Figure 2. Relationship between number of lake sturgeon fall fingerlings (male and female) stocked and time to meeting the adult spawning female objective.

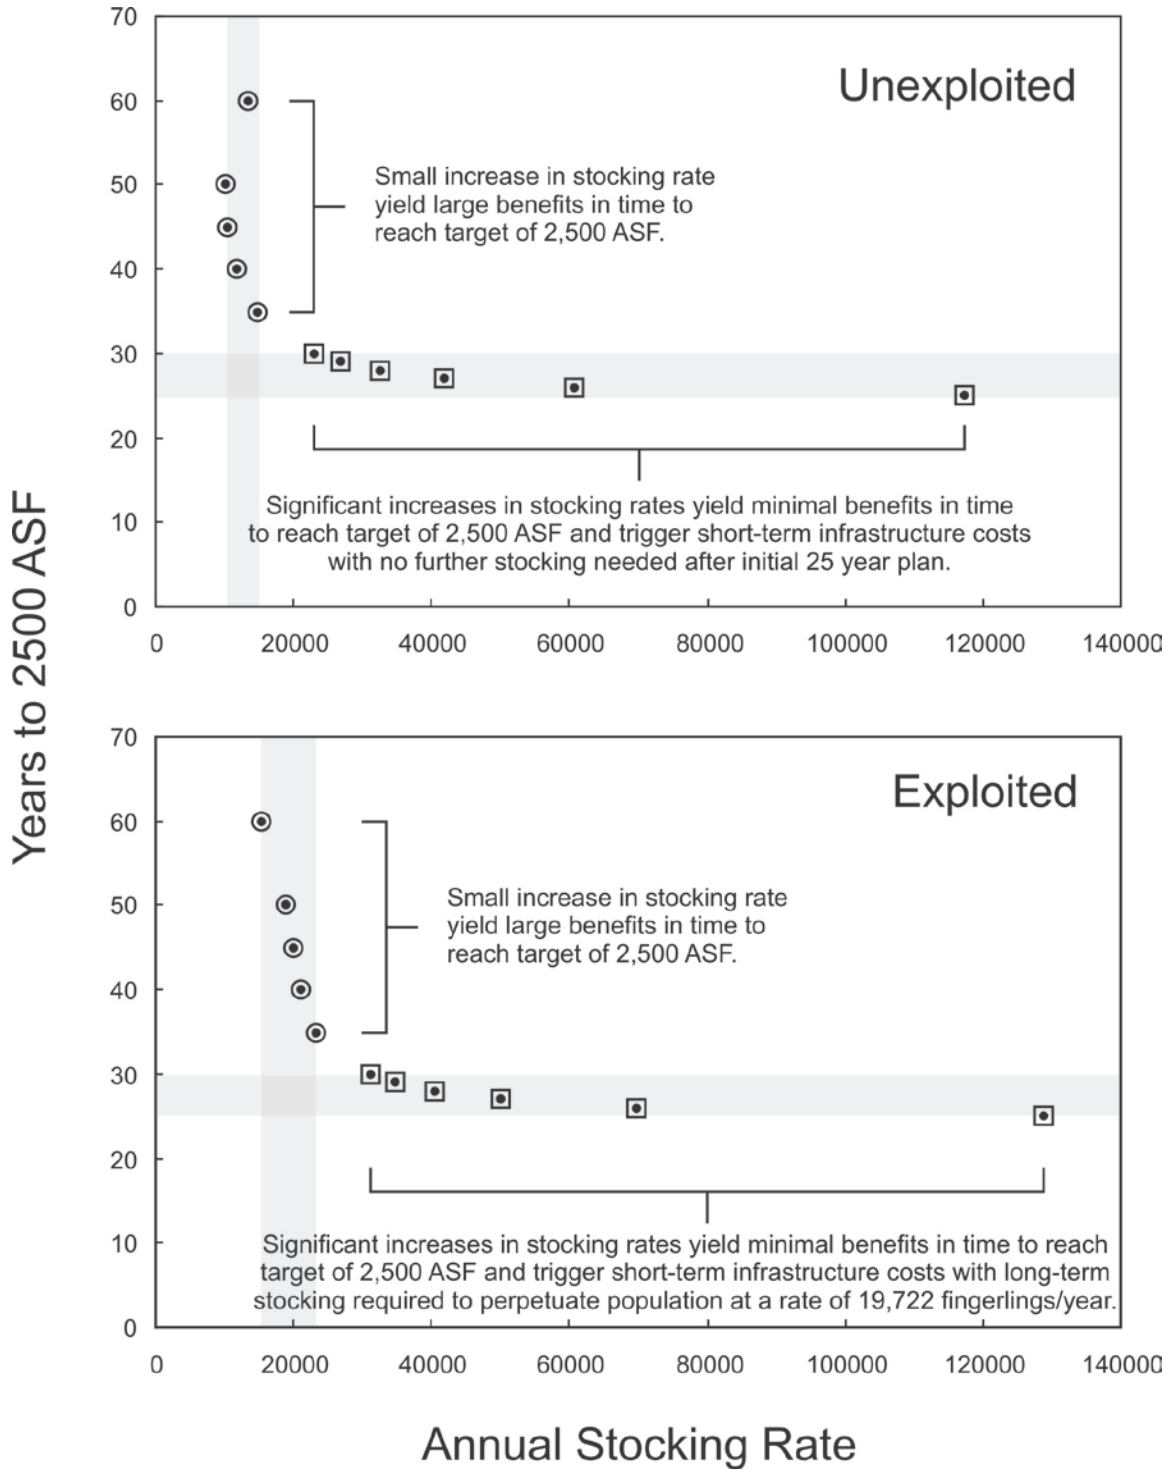
87 Three potential scenarios were explored and compared to determine the potential
 88 impact that ongoing harvest would have on the time to achieve the ASF objective
 89 (Figure 2). The stocking rate chosen for this comparison was the minimum rate that
 90 would achieve the ASF objective with both natural and fishing mortality factored into
 91 the adult survival rate.

92 1. **Unexploited Population** – This scenario (Figure 2 - top-most graph) assumes that
 93 only natural mortality (6.7%) would determine adult survival rates (i.e., no lake
 94 sturgeon fishing). Under these conditions, annual stocking of 19,722 fall fingerlings
 95 (includes both sexes at assumed 1:1 gender ratio) for 25 years would achieve the
 96 2500 ASF objective in 32 years. Survival rates used in the model were as follows:

101 2. **Exploited Population** – This scenario (Figure 2 – middle graph) shows how fishing
 102 mortality (in addition to natural mortality) would affect attainment of the ASF
 103 objective under the same stocking plan as above. No direct estimate of fishing
 104 mortality is available for the area. Therefore, an estimate of 8.3% was derived from
 105 the difference between the estimated population survival in the Nelson River
 106 between Clark Lake and Gull Rapids (85%) and the average adult survival provided
 107 by DFO (2010) (93.3%). Use of this estimate may result in an over-estimate of the
 108 effects of fishing mortality on the population as it was applied to the entire Kelsey
 109 to Keeyask reach, and fishing mortality in the other parts of the reach may be lower
 110 than in the Clark to Gull Rapids reach. Survival rates used in this run of the model
 111 were as follows:

Of these three scenarios, it is recommended to use Scenario 3 as the basis for setting initial annual targets for stocking density. It is assumed that a sturgeon harvest on the Nelson River would continue since it is culturally important. It is important to note that lake sturgeon year-class strength and the proportion of the hatchery reared versus wild fish that comprise each year class will be monitored annually. Stocking rates would be modified based on monitoring results, to avoid either under or over-stocking.
